Wiring Terminal differences DSLC-2 / DSLC-2XT

Clemens - 2024-03-19 - DSLC-2

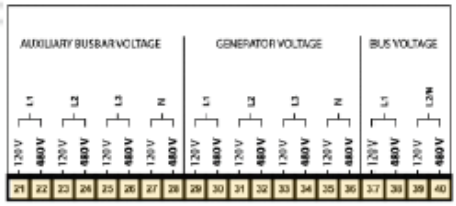
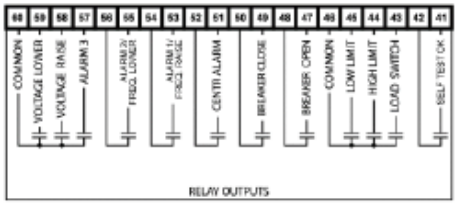
See here wiring & terminal differences between DSLC-2 and DSLC-2XT

Differences are mainly related to analog outputs and AC voltage sensing terminals.
